ARCHITECTURAL ACCESS BOARD- HEARING PACKET

Name	Salem YMCA	Docket #	V 25 - 089		
Address	1 Sewall Street	Docket #	C -		
City	Salem	Hearing	8/24/2026		
Bldg Type		Time of hearing	11:00 AM		
Complaint's Name		Plans on file?			
Complaint ?	Variance ?	Request for continuance?			
Jurisdiction:	3.3.2	If the work performed amounts to 30% or more of the full and fair cash value of the building, the entire building is required to comply with 521 CMR.			
Building Permits:	Anticipated construction cost: \$3,500,000				
Assessed Value:	\$4,226,800

Exhibit: 1
V25-089
AAB 1-117

Petitioner seeks relief from: 26.6: A minimum clear floor area shall be provided on both sides of all doors and gates.

LEVEL 1 - PLAN	
DRAWING TITLE	
SCALE 3/32" = 1'-0"	
DATE 31 MARCH 2025	
JOB NUMBER 24001	
CONSTRUCTION DOCUMENTS	
SUBMISSION	
DRAWING NUMBER	
A-101

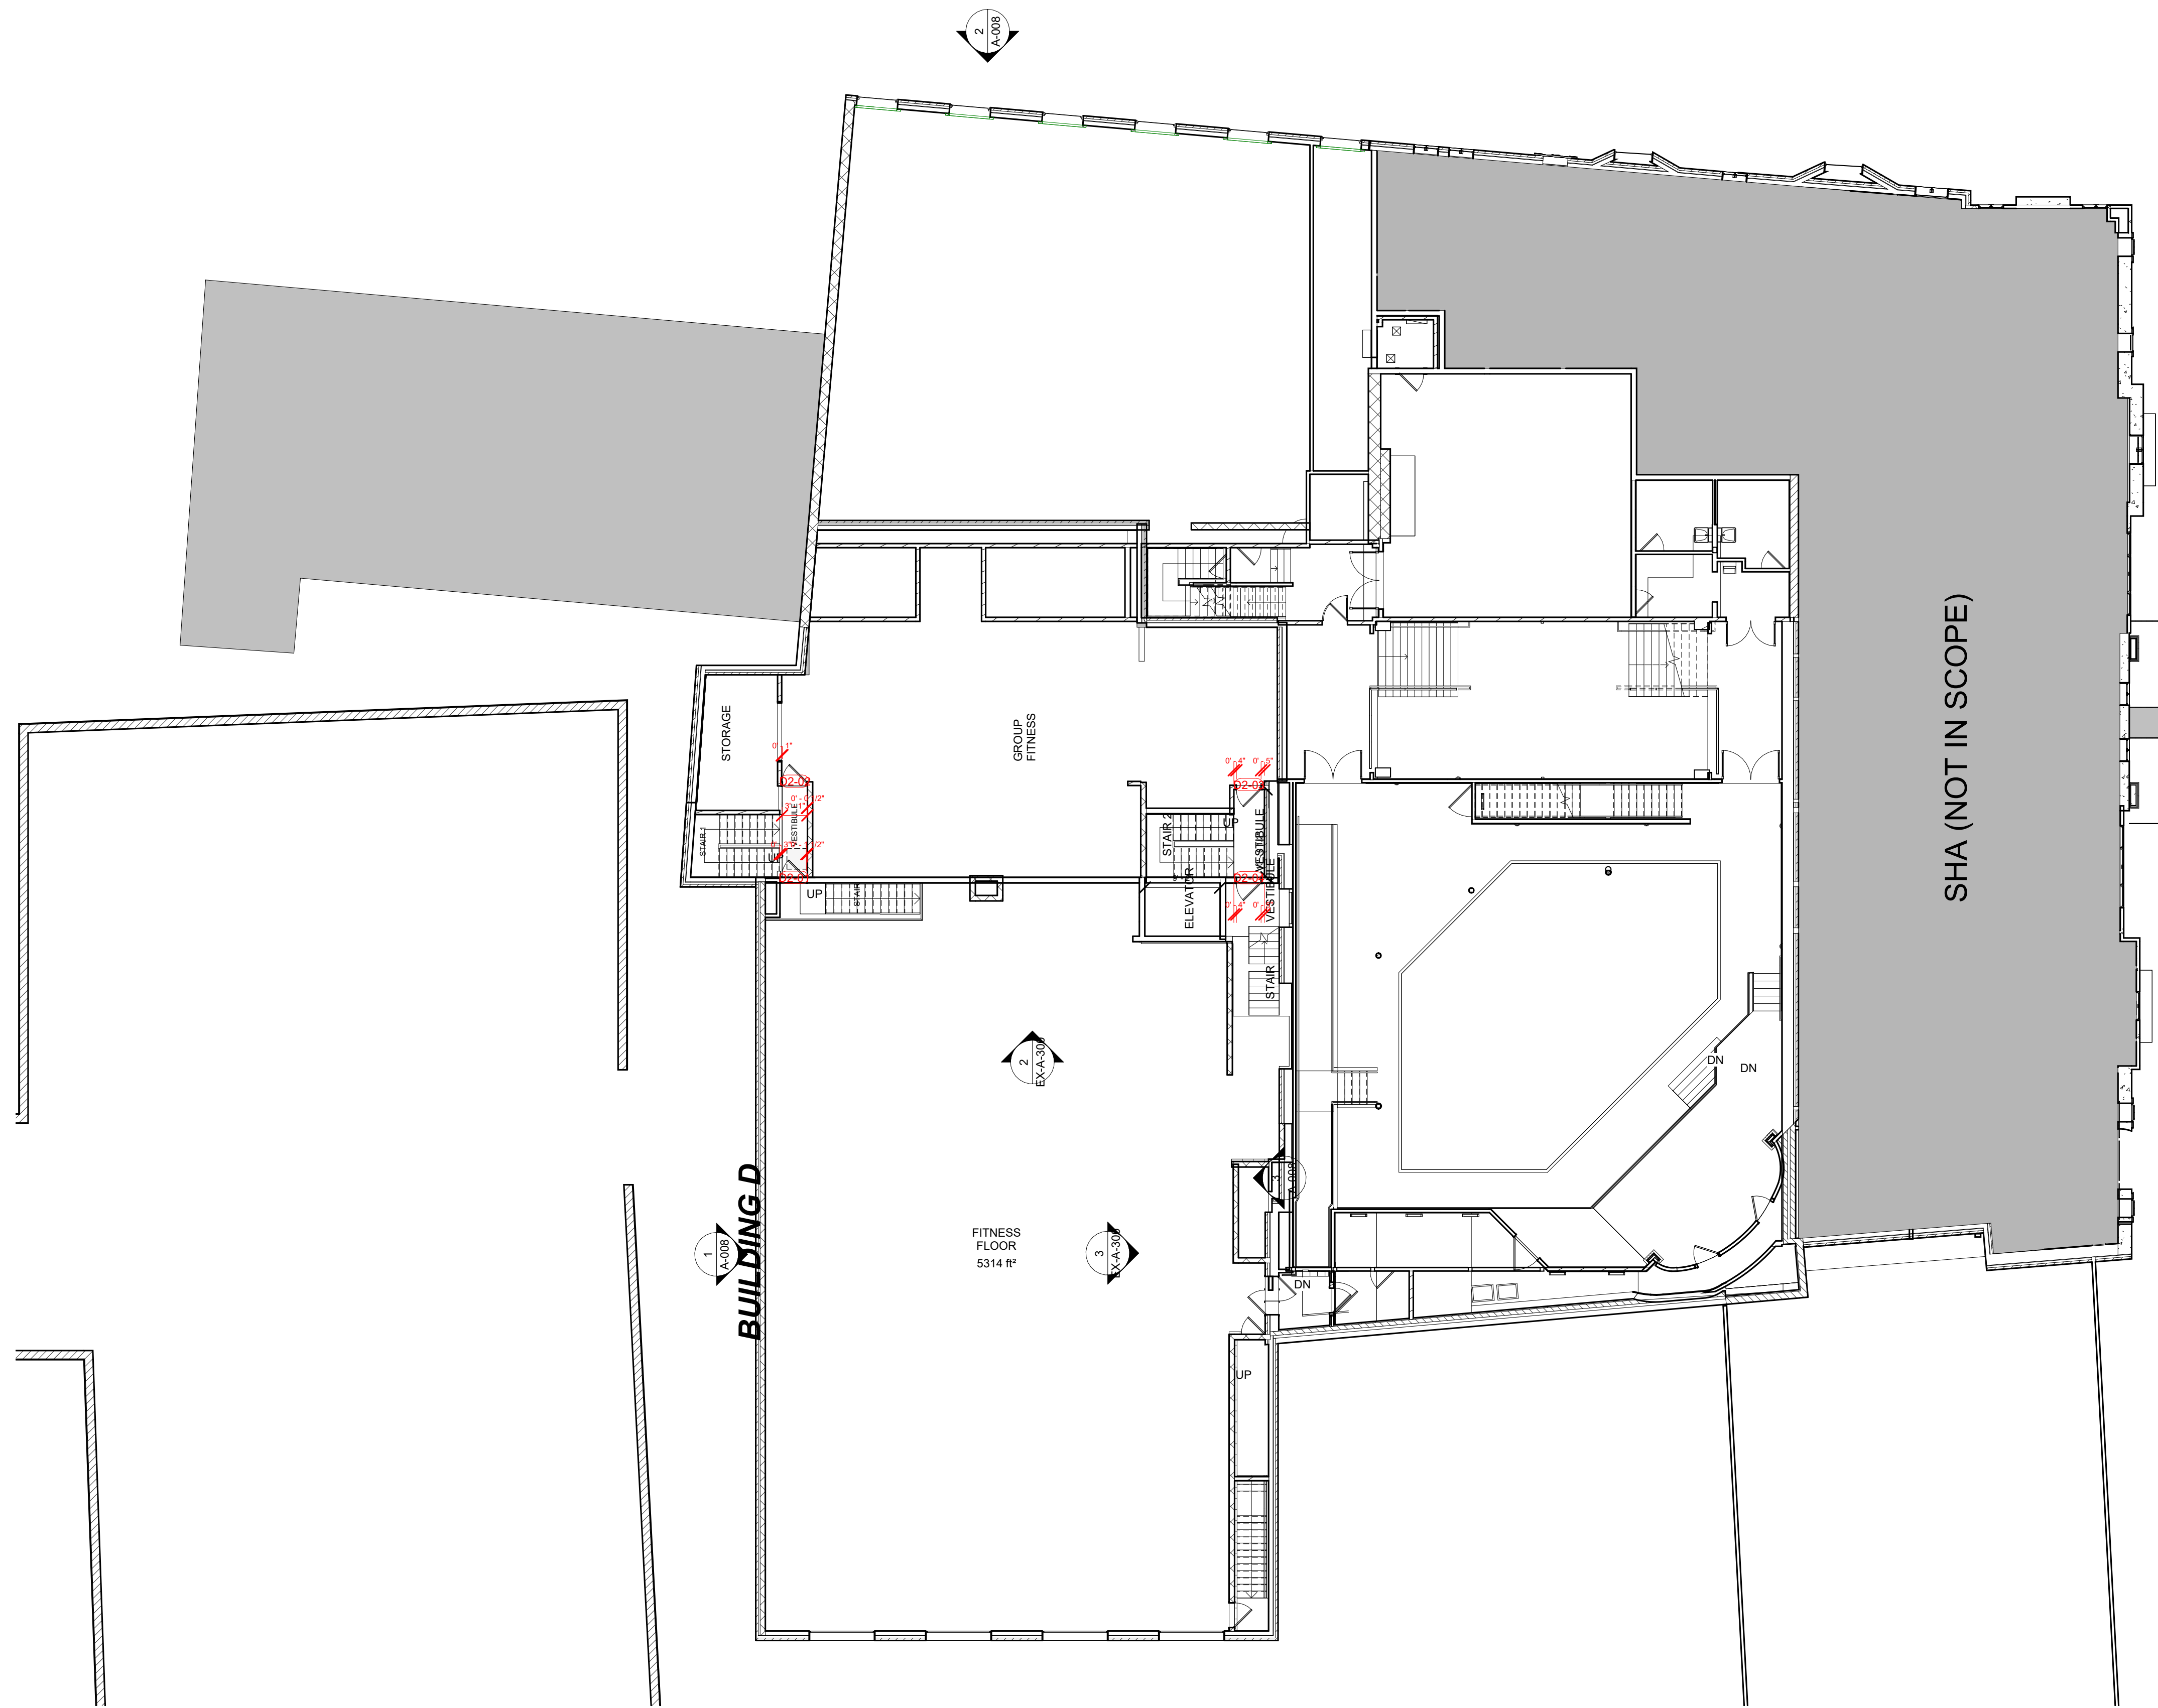
1. Plan identifying doors and spaces impacted by this request.
2. Labelling of spaces and dimensional information on clearances that will not be met for the doors being requested for relief.

1. See Attachment A for floor plans / information on each door requesting relief. The doors highlighted in red on the spreadsheet indicate the deficiency and potential remediation / associated rough costs.

1 LEVEL 1 FLOOR PLAN - EXISTING & DEMO
SCALE 1/4" = 1'-0"

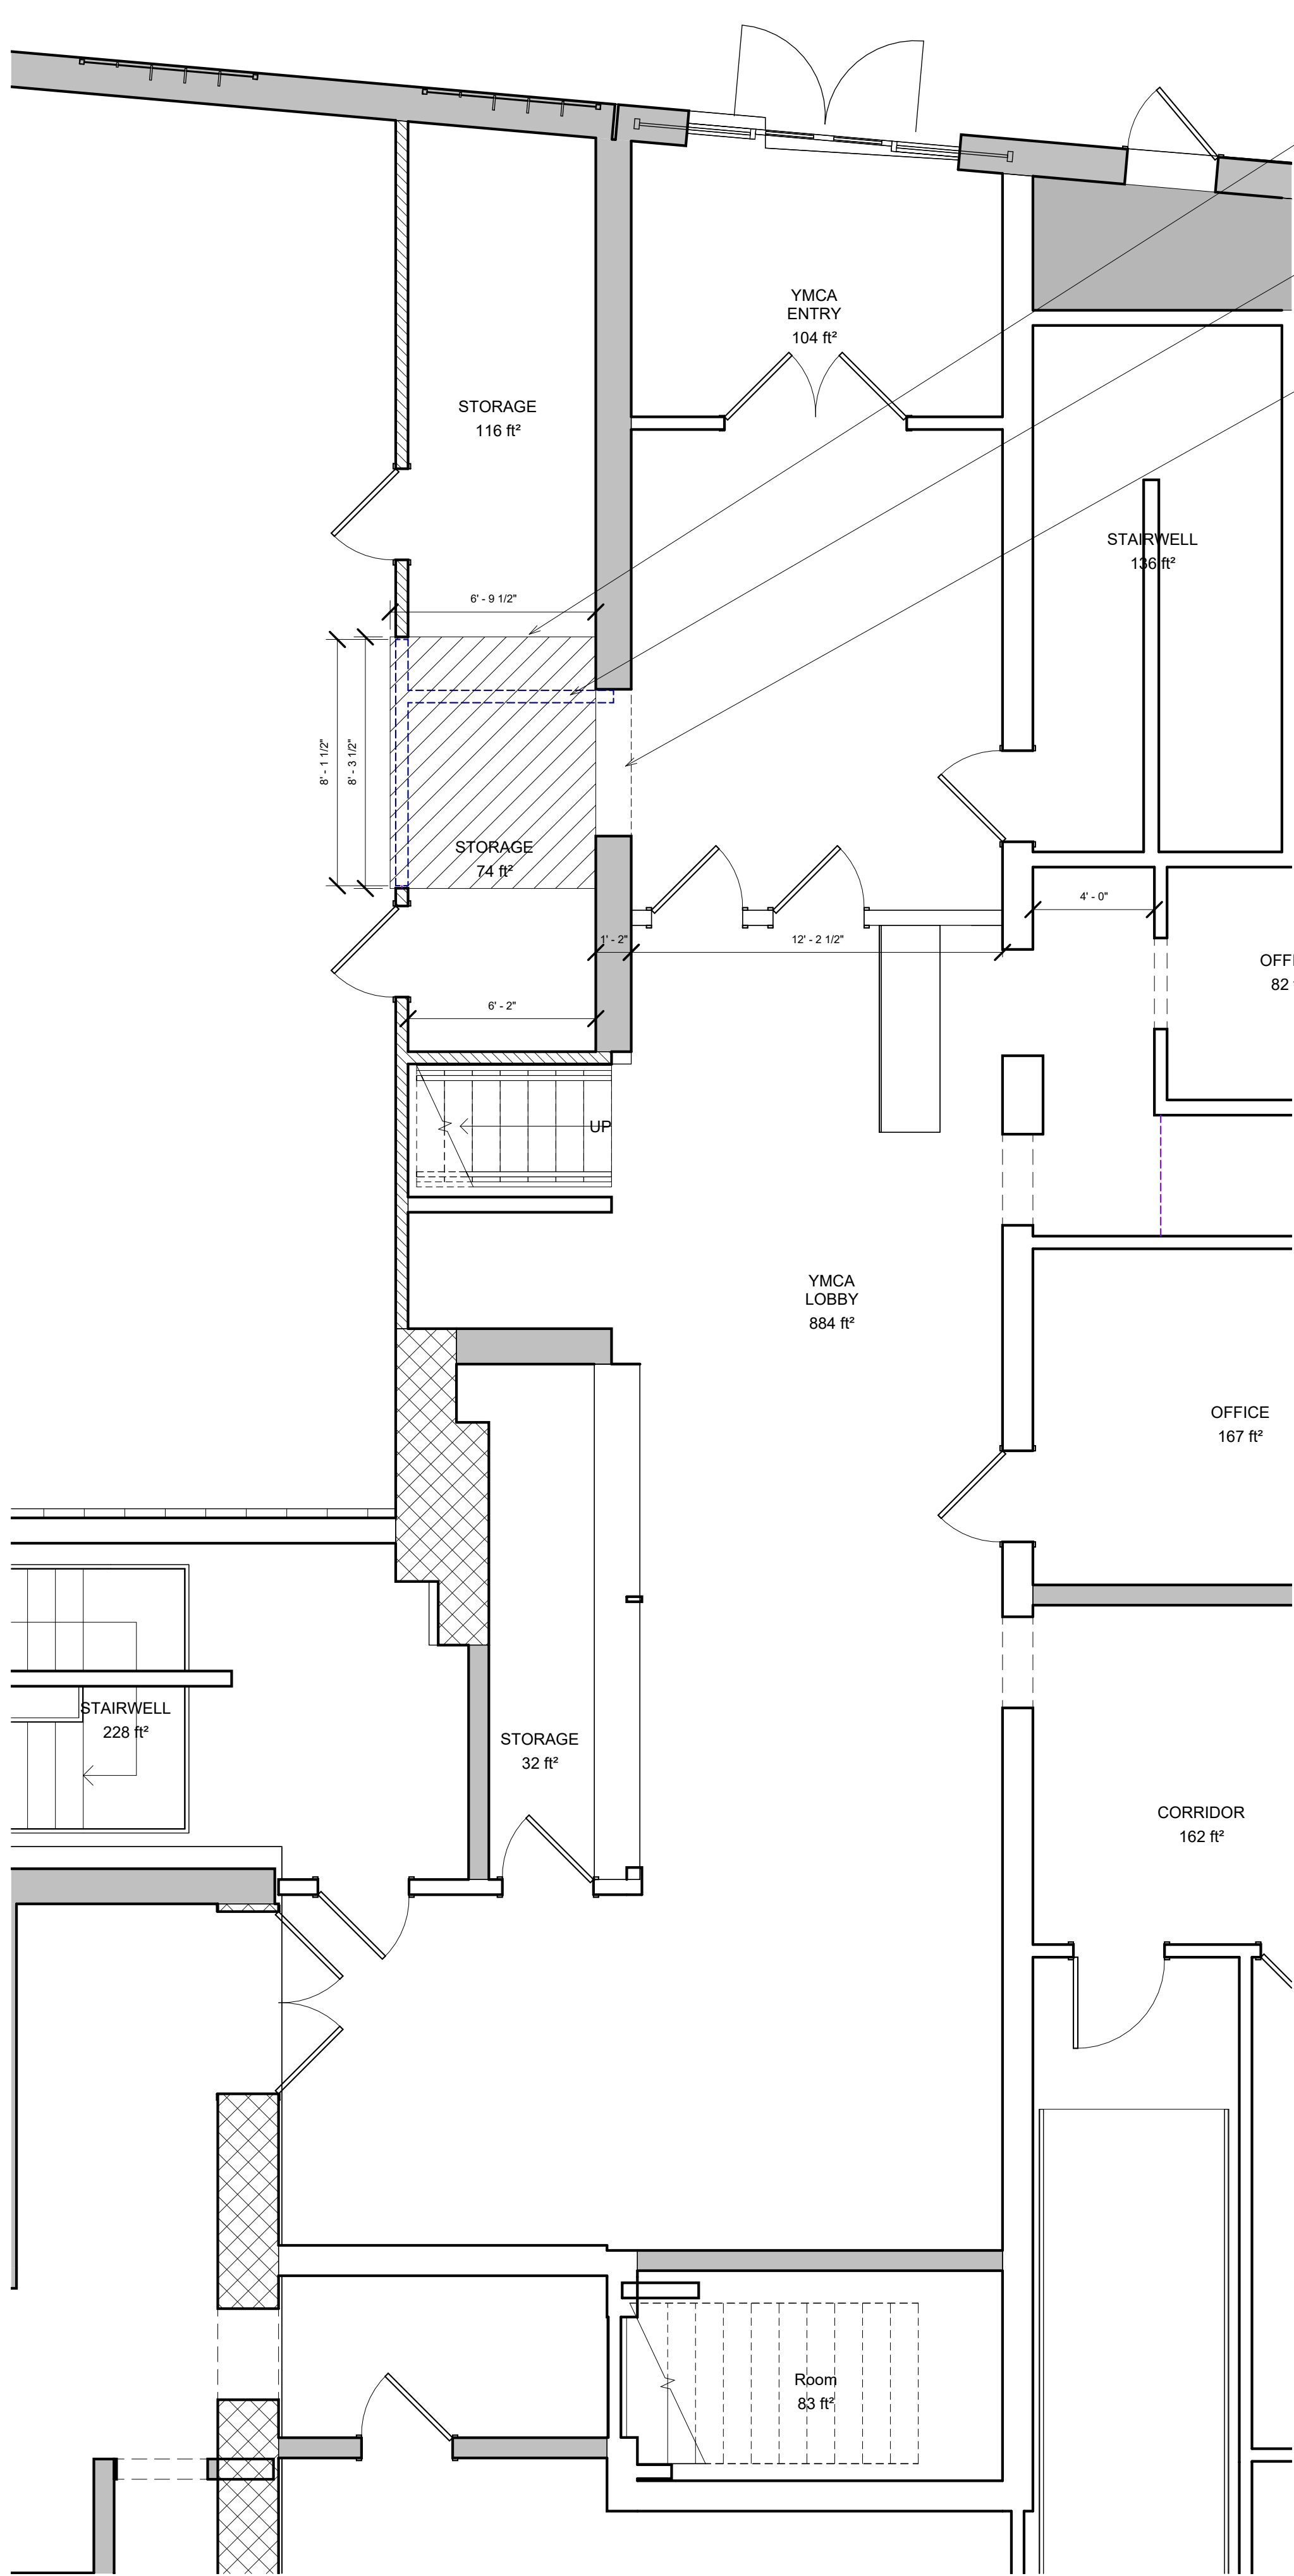
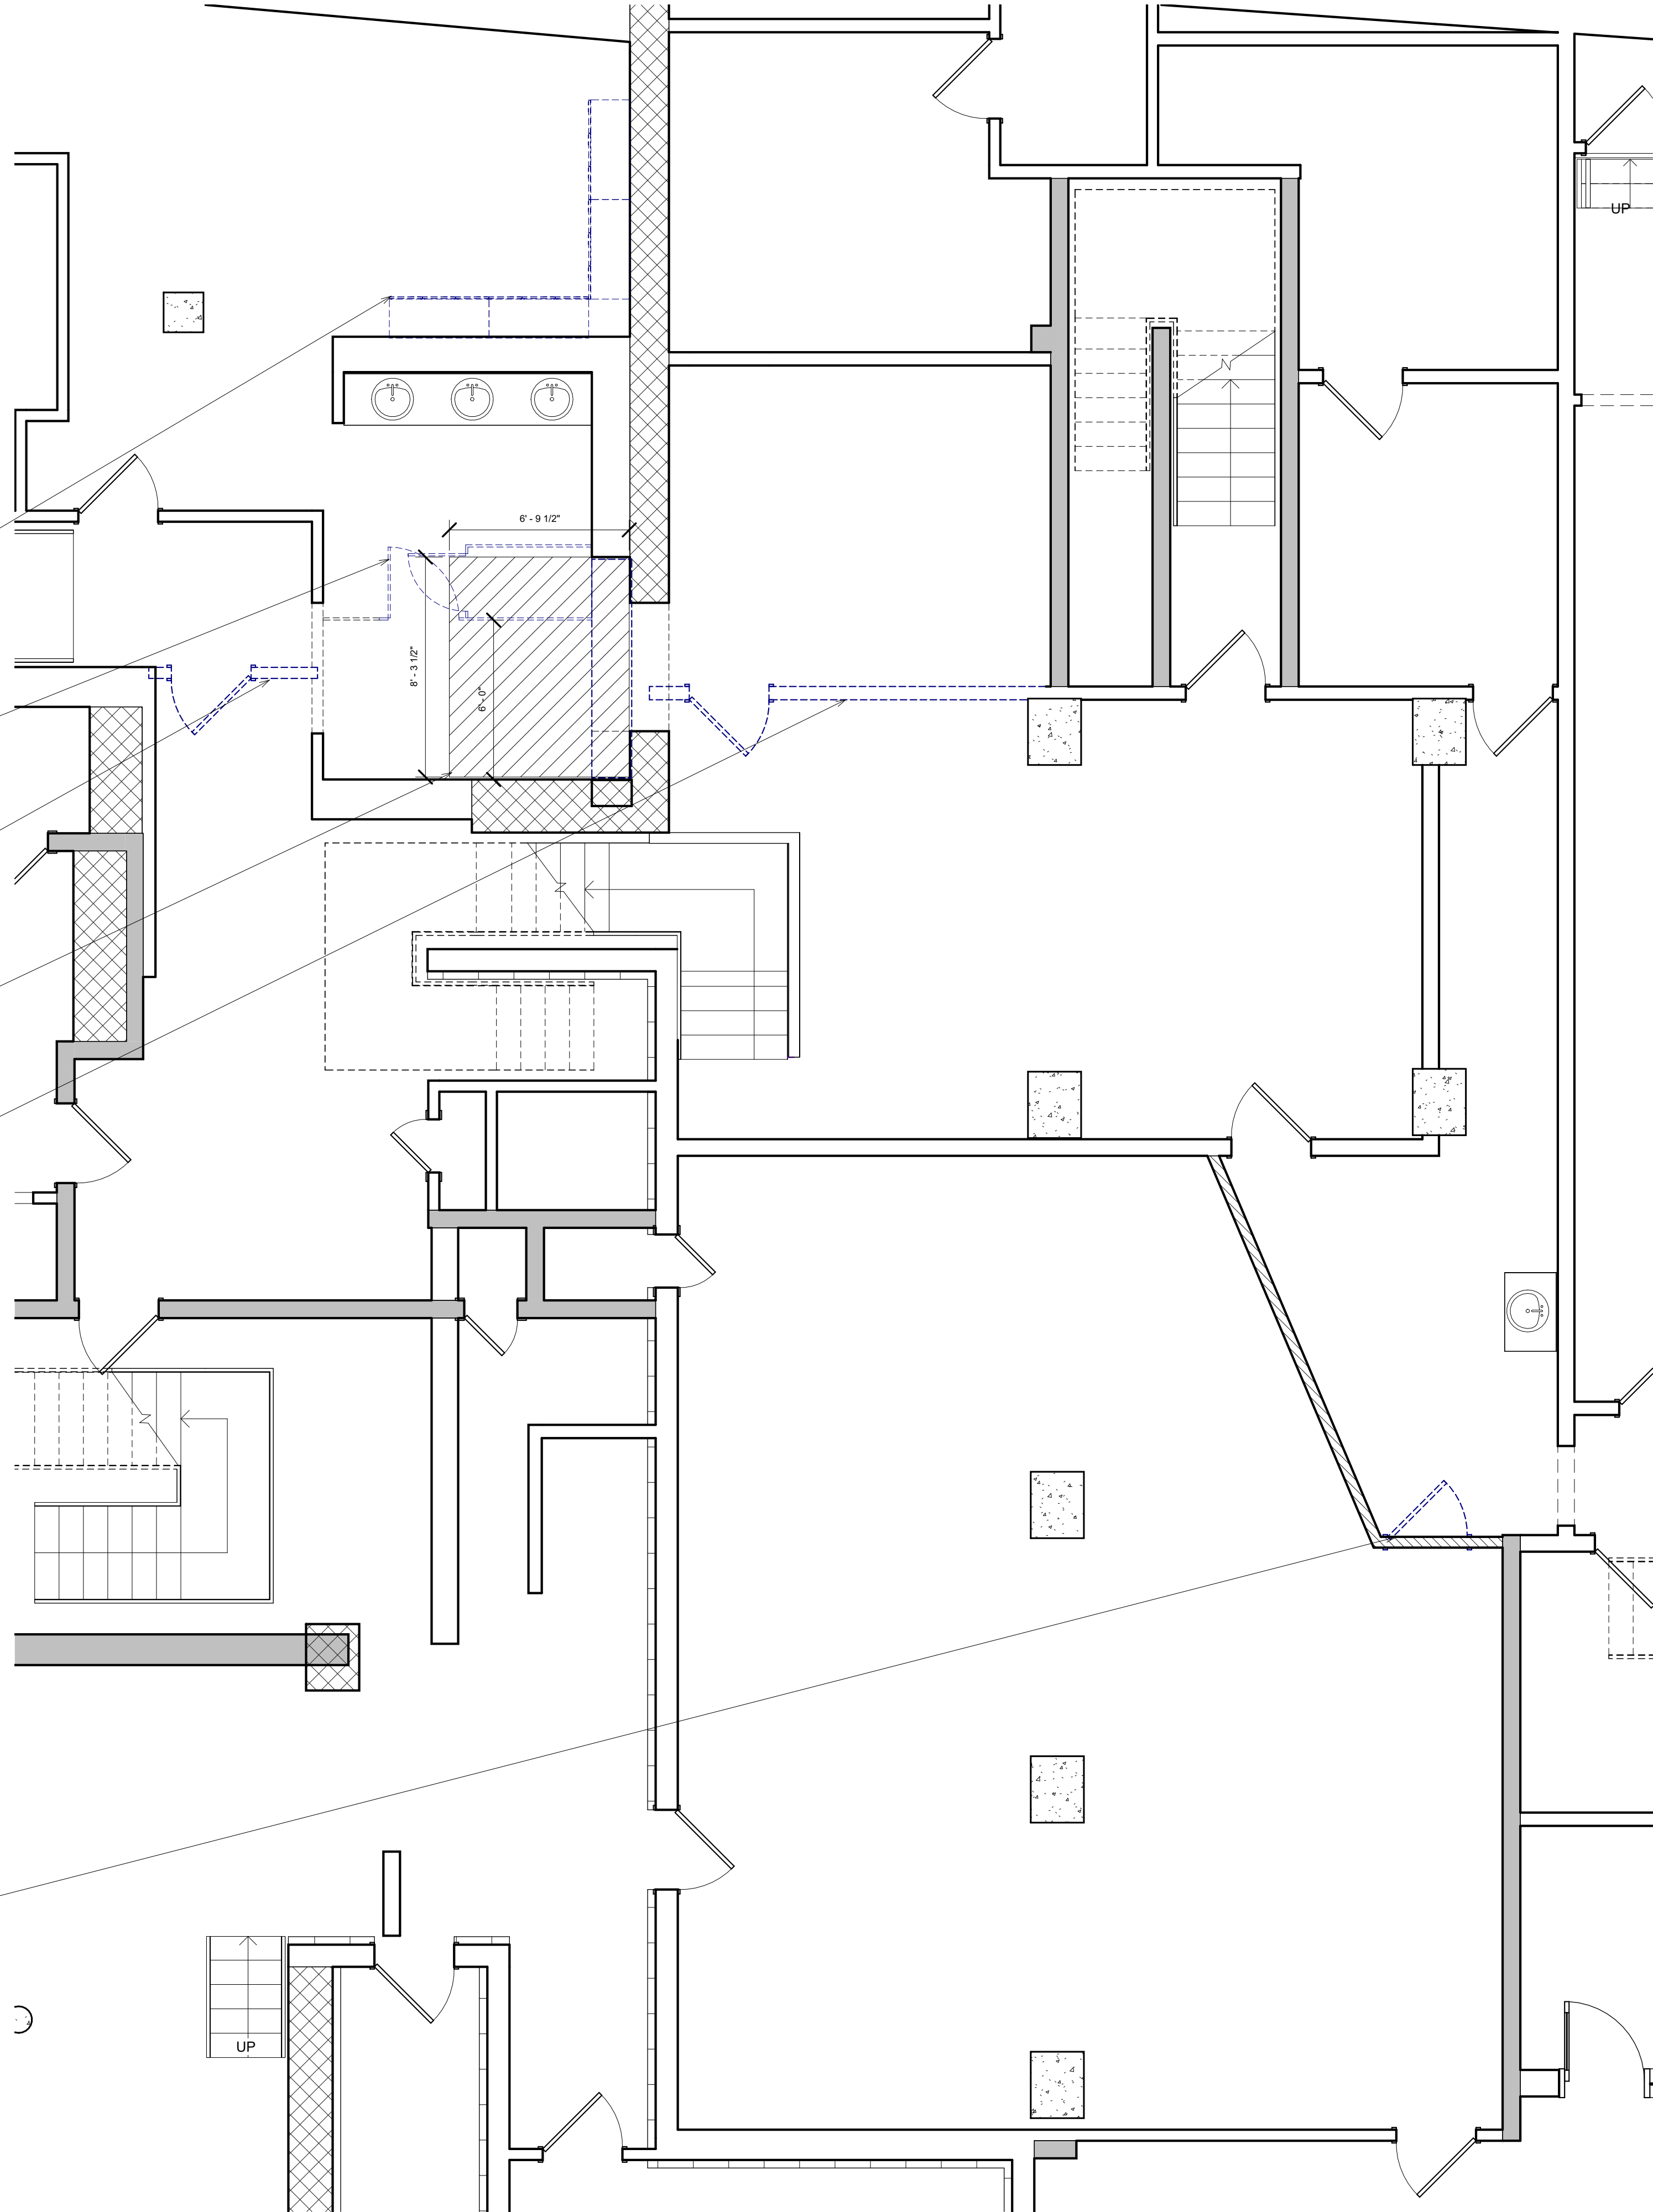
- to **CONTINUE** Petitioner's Request 1 for relief from 521 CMR 20.1 (entrance) and 28.1 (elevator) and **ORDERS** Petitioner to provide the Board with: (1) test drawings for a permanent or portable lift to the basketball court; and, (2) the policy on relocating on request special programming in the basement;

1. See Attachment C for test drawings to provide an accessible route to the flex gym space. Note that the scope of work includes (1) adding another stop to the elevator and opening the existing shaft wall and (2) construction of a new ramp to access the space.
2. See Attachment A for the written policy for relocating the special programming throughout the facility.
